**Ivas Environmental
Environmental Sciences
Wetlands and Planning Services**

**City of Boston Conservation Commission
Boston City Hall
1 City Hall Square
Boston MA 02201**

RE: MA DEP File #: NE - 006-1816, 155 Porter Street, East Boston

This letter covers the attached package of information provided to the City of Boston Conservation Commission. It is written as a response to Mr. Moreno's comments of 03 Nov 21 regarding the proposed project at 155 Porter Street.

SHEET TITLE: BUILDING SECTIONS
SHEET NUMBER: A-300

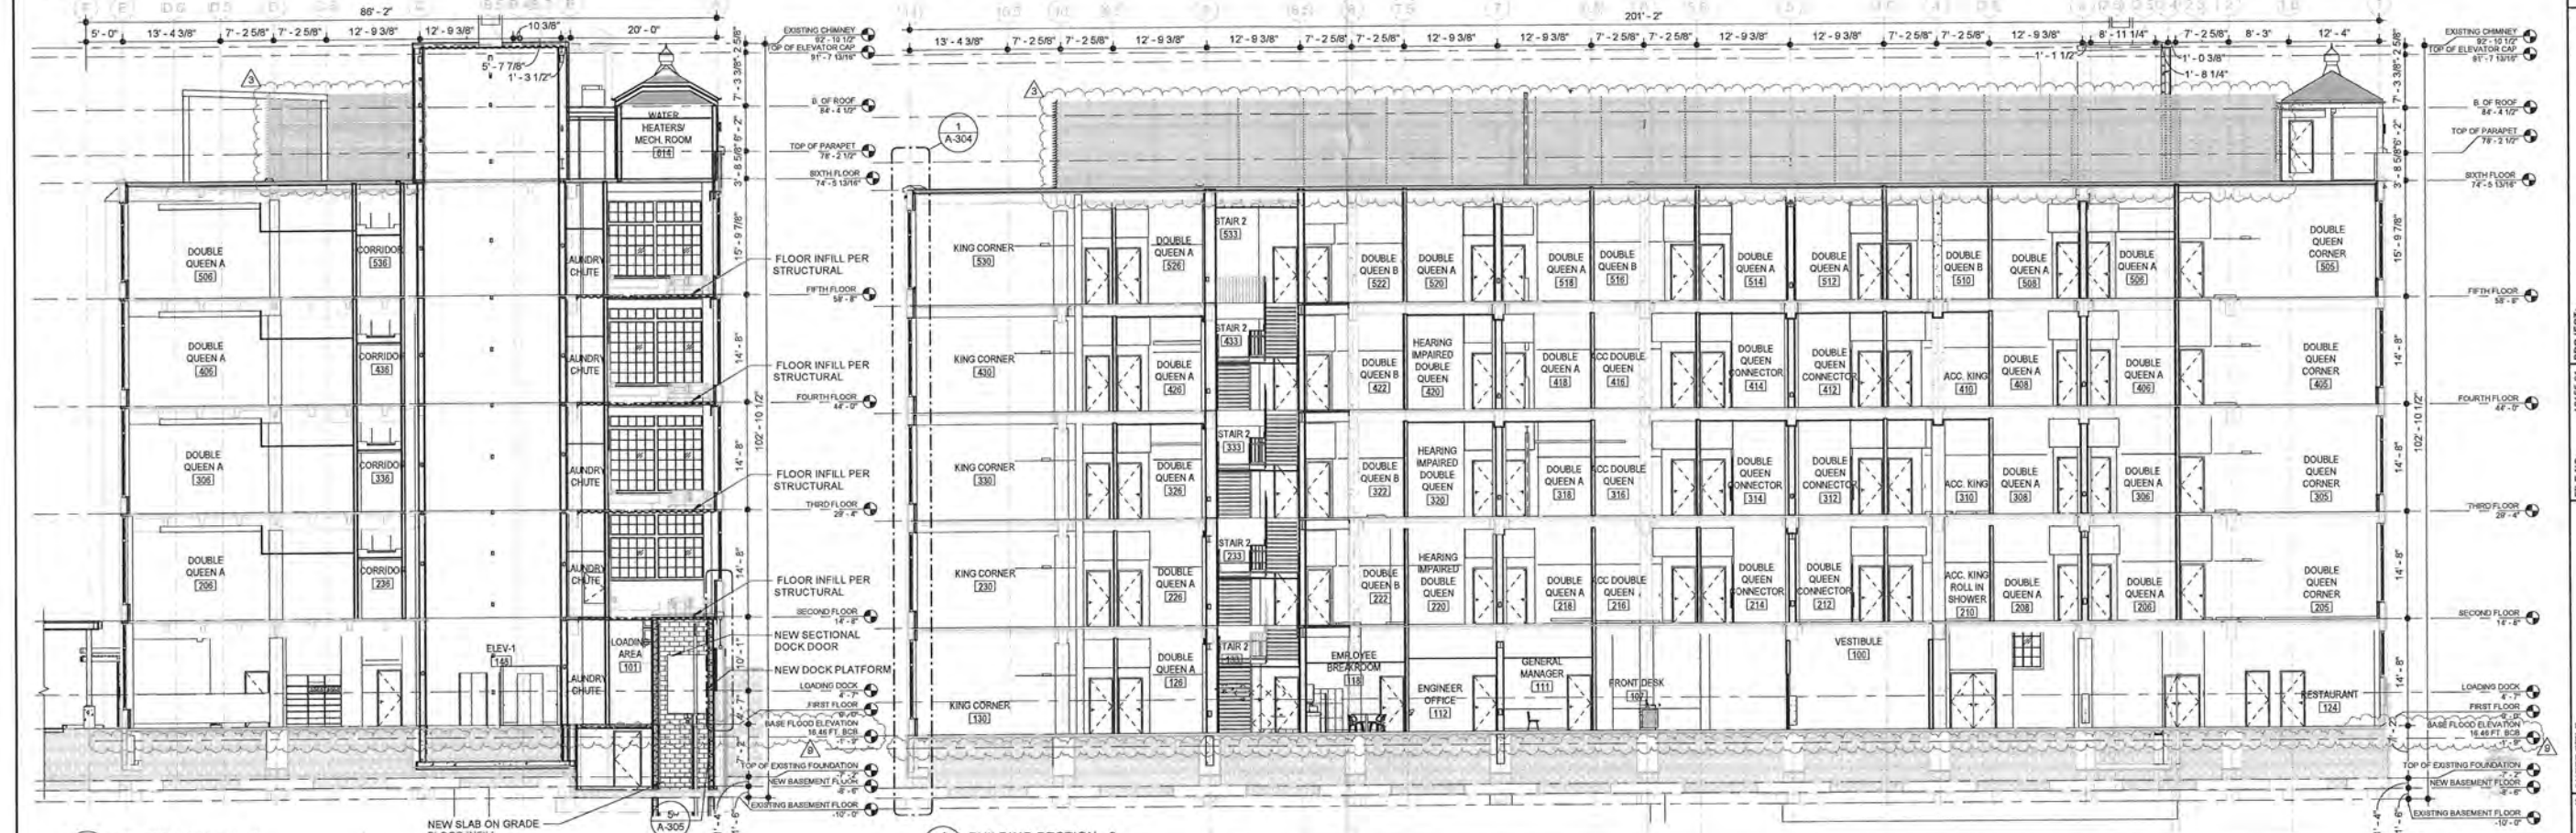
2. I am still having difficulty matching the proposed elevations on the Climate Resiliency Checklist to the plan set that was provided. Can you highlight those elevations on the proposed grading plan (C102)?

B. An 11 x 17 inch print of the Building Sections is included. These are plans A-300, A-301, and A-302. The elevations are found adjacent to the buildings, on the right side, on each plan.

SHEET TITLE: BUILDING SECTIONS
SHEET NUMBER: A-300

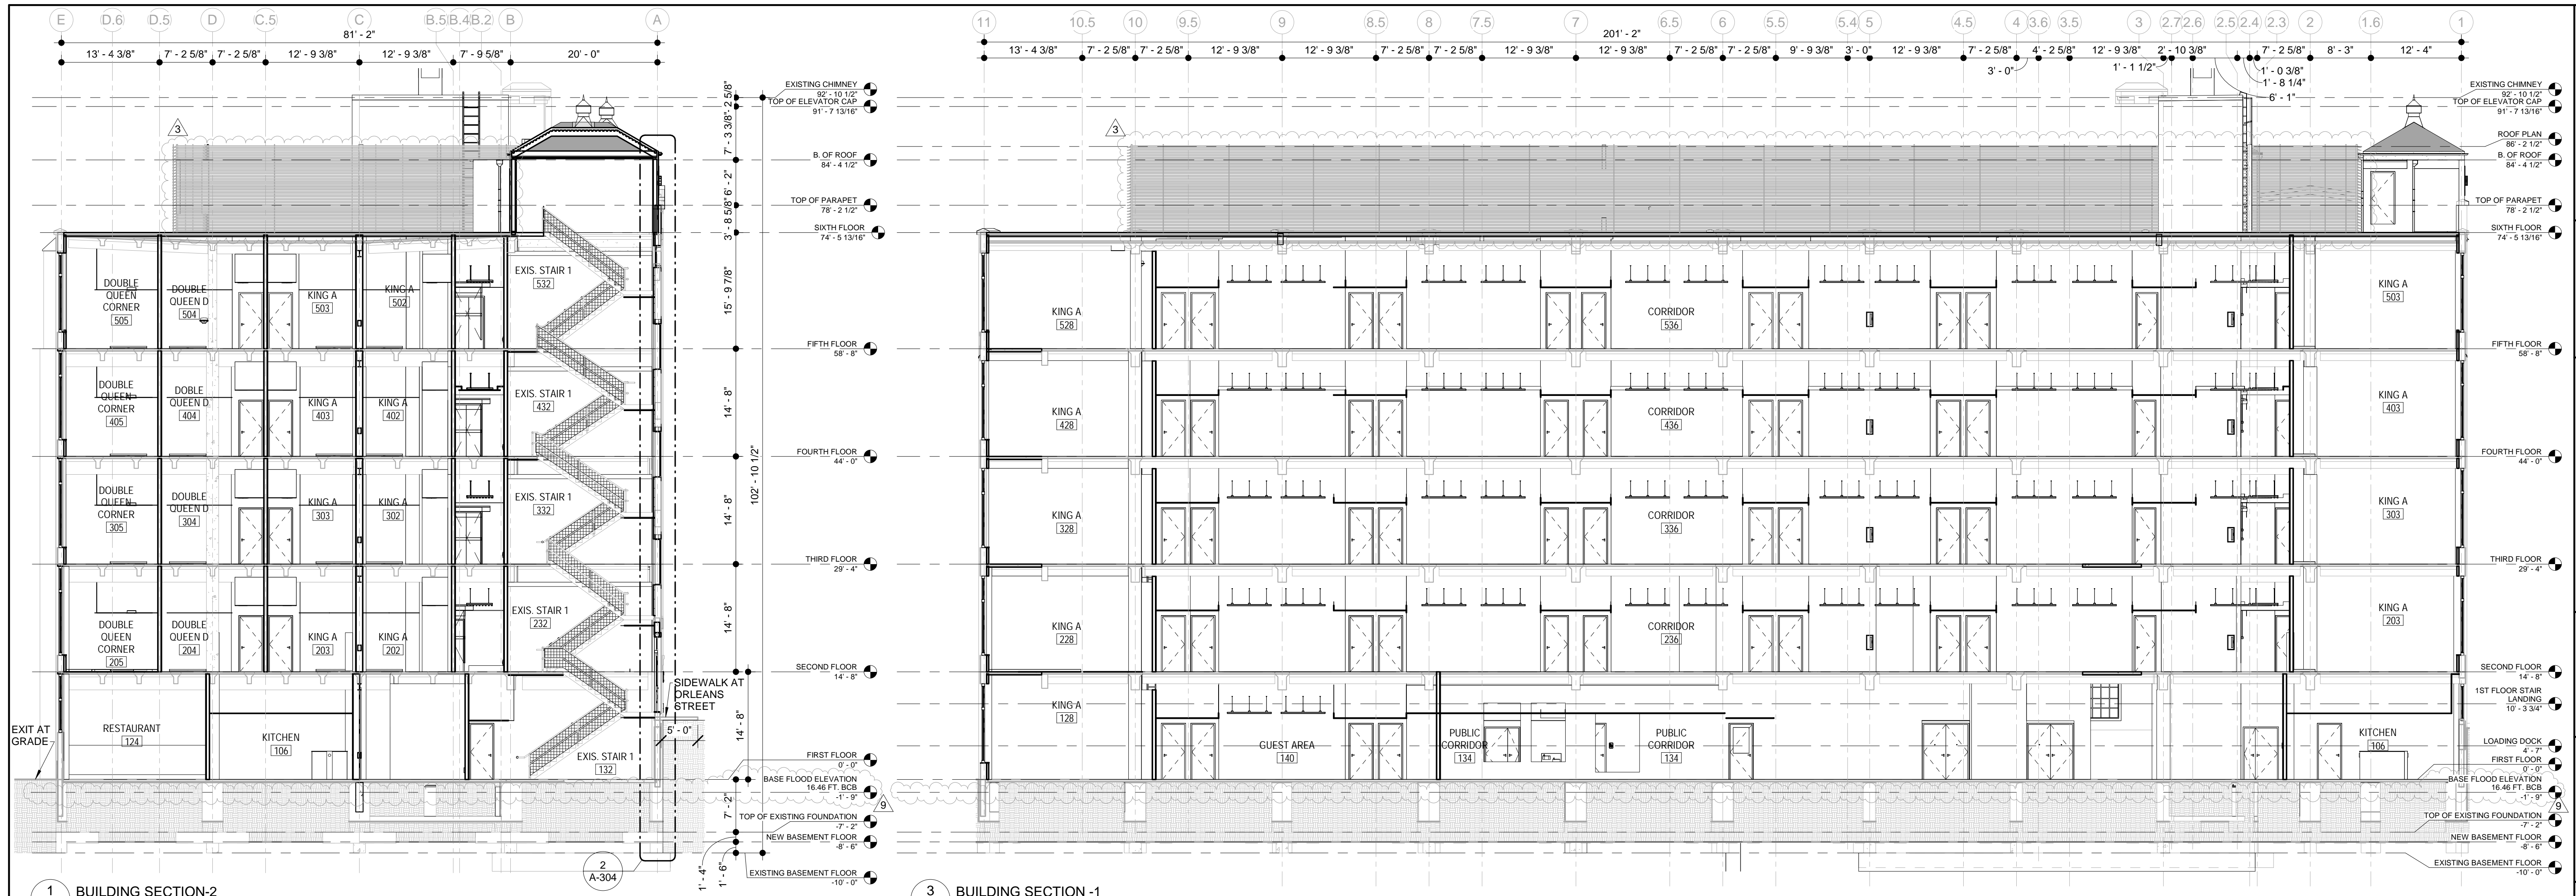
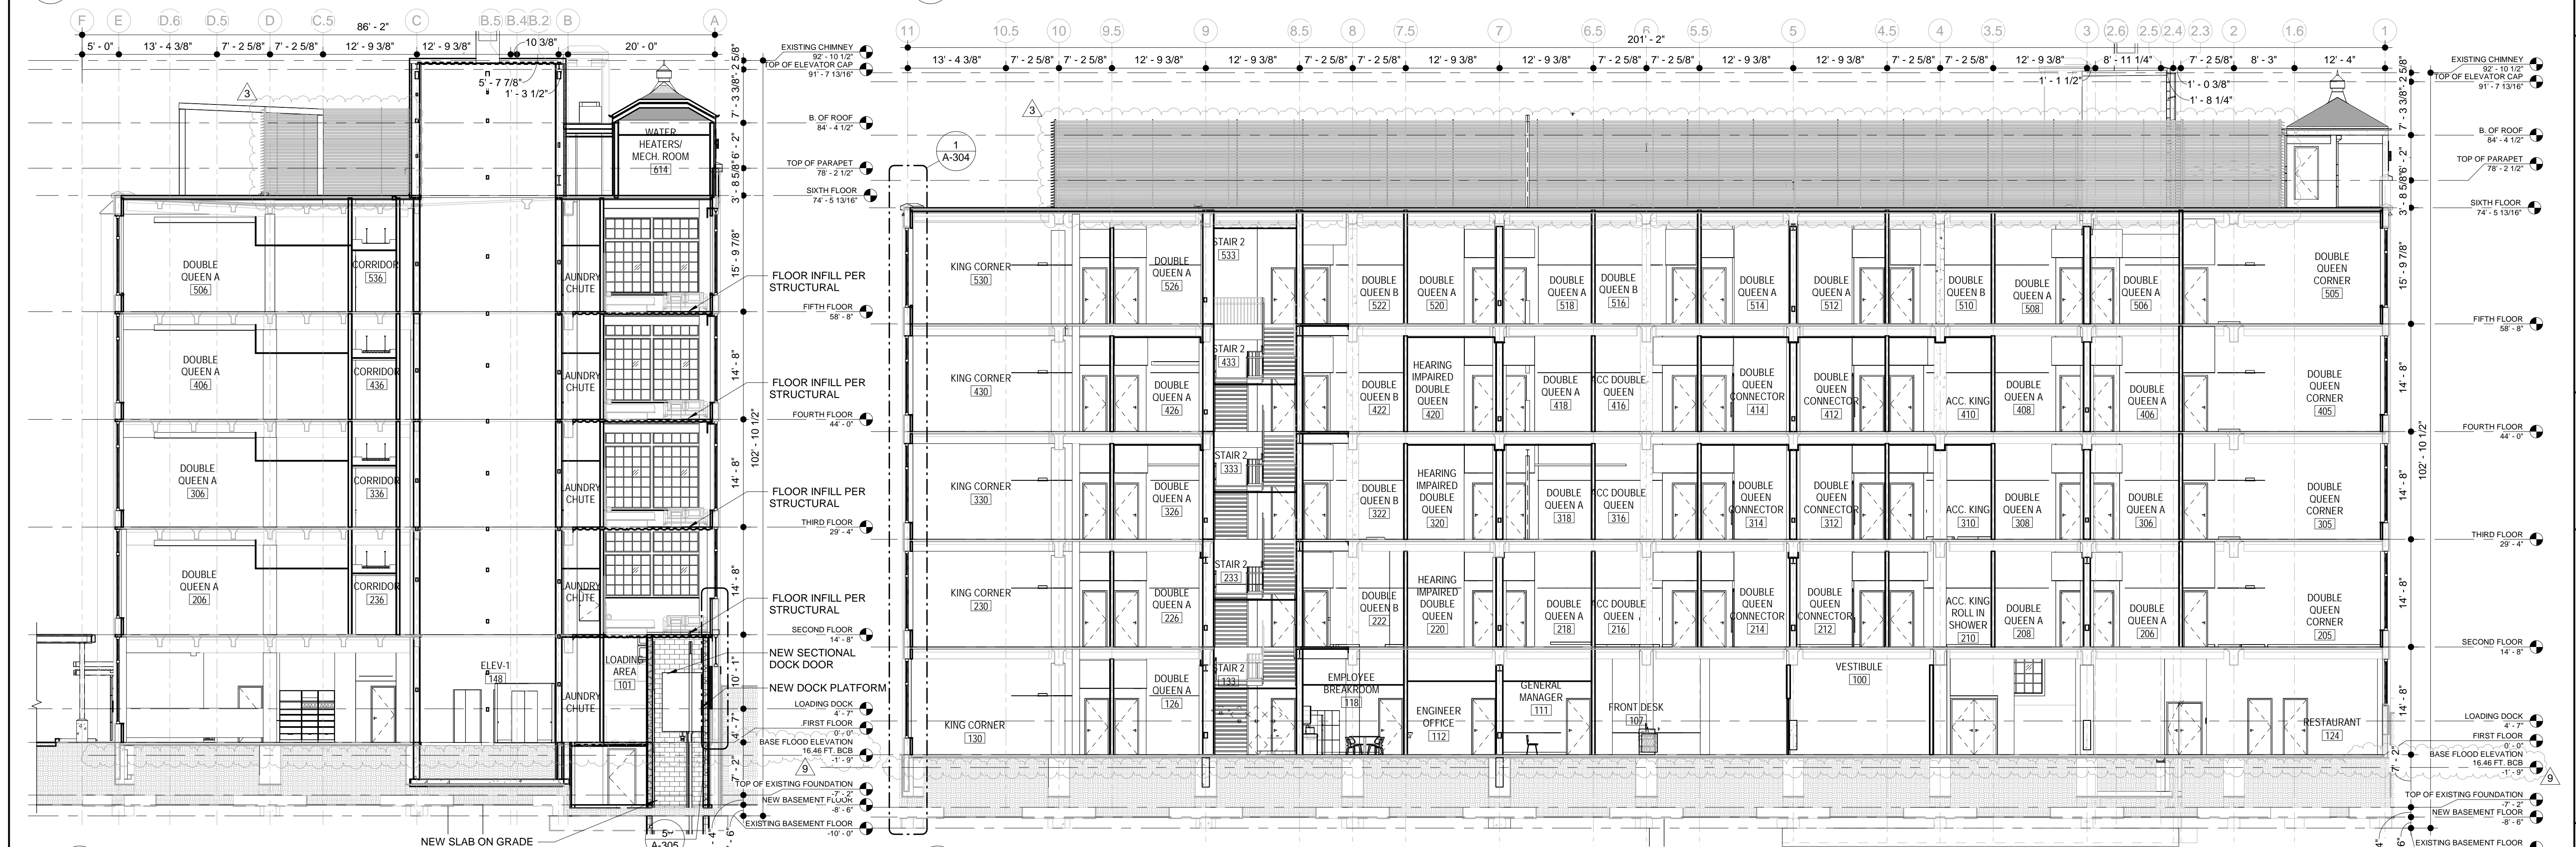
8. Please also include the base flood elevation line on the building section plans.

The base flood elevation has been provided on the building section plans attached.
